TO: Mayor and Council
FROM: Hal Simmons, Planning and Development Services
NUMBER: **ORD-36-18**
DATE: June 21, 2018
SUBJECT: CAR18-00003 / JH Development / Ordinance

Ordinance NO. ORD-36-18

THIRD AMENDMENT TO DEVELOPMENT AGREEMENT FOR
BOULDER HEIGHTS ESTATES

SUBJECT: **Boulder Heights – Modify Starview Drive Requirements**
Staff Report for April 25, 2018 Commission Meeting

HAIRPIN CURVE LINE OF SIGHT

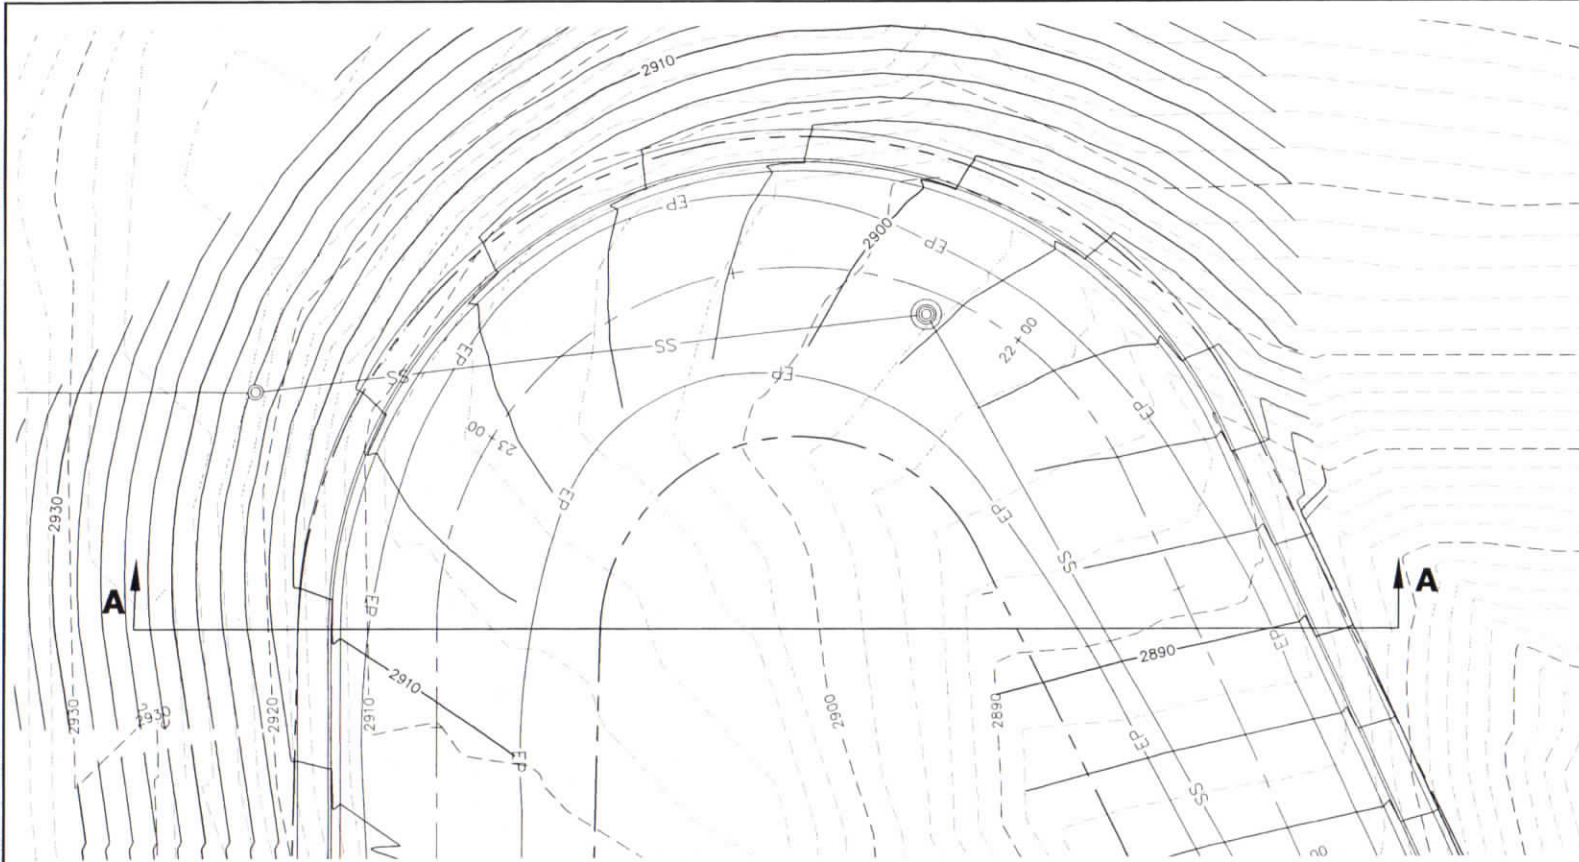
- Two 11-foot travel lanes
- 5-foot wide bike lane on the uphill side adjacent to the travel lane
- 2-foot curb and gutter on uphill side
- 5-foot wide attached sidewalk on the uphill side (with guardrail)
- 1-foot wide paved shoulder on downhill lane
- Jersey barrier (as needed)
- Improve safety and site distance at the hairpin curve with additional pavement widening through the curve, and removal/replacement of landscaping that inhibits site distance at that location

3. Improve safety and site distance at the hairpin curve with additional pavement widening through the curve, and removal/replacement of landscaping and other obstructions that inhibits site distance at that location

Proposed Modification to Starview Drive Requirement

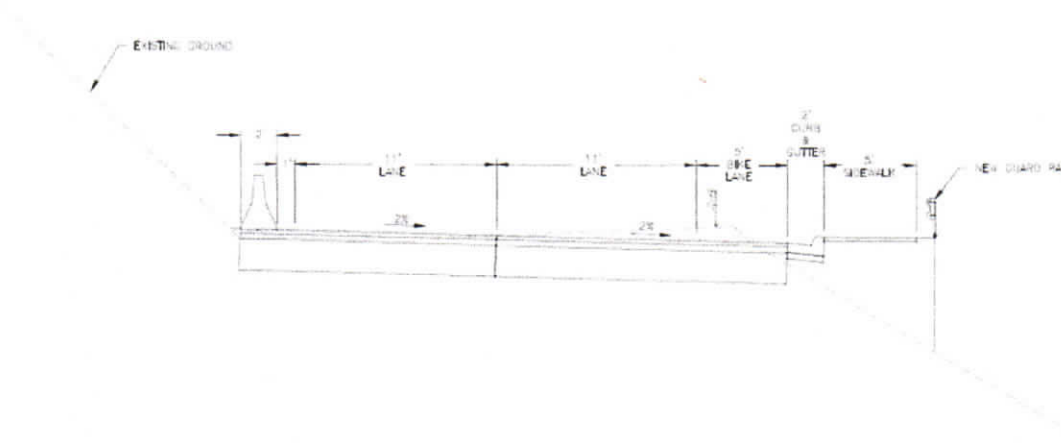
To avoid significant re-grading of the hillside that could result in cuts up to 30-feet in depth the applicant is requesting that Site Specific Condition #5 (from 2002) be modified to remove the requirement to re-grade Starview Drive to a maximum grade of 10.25%. The applicant is proposing to reconstruct the road, as required, and will improve grades where feasible. The applicant's engineer has provided preliminary engineering to demonstrate that re-grading the road would be difficult, if not infeasible in some sections, due to the geological constraints of the hillside, and the required lengthening of the road that would need to occur to achieve grades of less than 10.25%. Staff concurs with this

analysis, and based on the attached engineering documents, recommends that the condition be modified to “improve the grade where feasible, and shall not exceed existing grades”.

- f. Jersey barrier (as needed) on downhill lane (outside the paved shoulder)
2. The grade of Starview Drive shall be improved where feasible and shall not exceed existing grades.

Starview Drive/Warm Springs Avenue Intersection

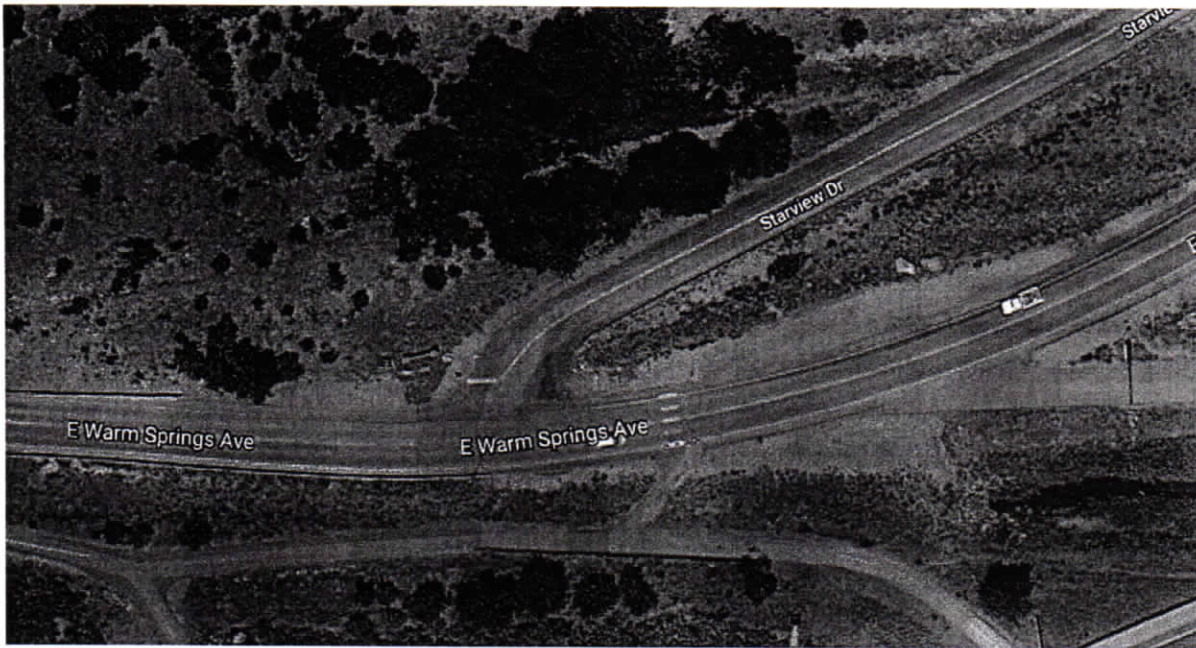
The applicant is proposing to reconstruct the Starview Drive/Warm Springs Avenue intersection to improve site distance and turning radius. The applicant is also proposing to extend sidewalk to the existing striped crosswalk that provides connectivity to the Greenbelt.

ACHD did not require the installation of a traffic signal at this intersection with the original application. Traffic Services has reviewed the crash data for the intersection and found that in the last 10 years there have been no crashes involving left turns from Starview Drive on to Warm Springs Avenue. Additionally, this intersection does not meet warrants for a traffic signal; however, improvements can be made to increase the site distance. When the applicant reconstructs the Starview Drive/Warm Springs Avenue intersection, the applicant may need to raise the elevation of the intersection and Warm Springs Avenue to improve site distance and safety.

4. Reconstruct the Starview Drive/Warm Springs Avenue intersection to improve site distance and turning radius. This may require that the grade of the intersection and Warm Springs Avenue be raised, and the applicant should coordinate a final design with ACHD staff.

5. Install an RRFB on Warm Springs Avenue at the existing crosswalk, and work with ACHD and Ada County to improve the existing connection to the Greenbelt.
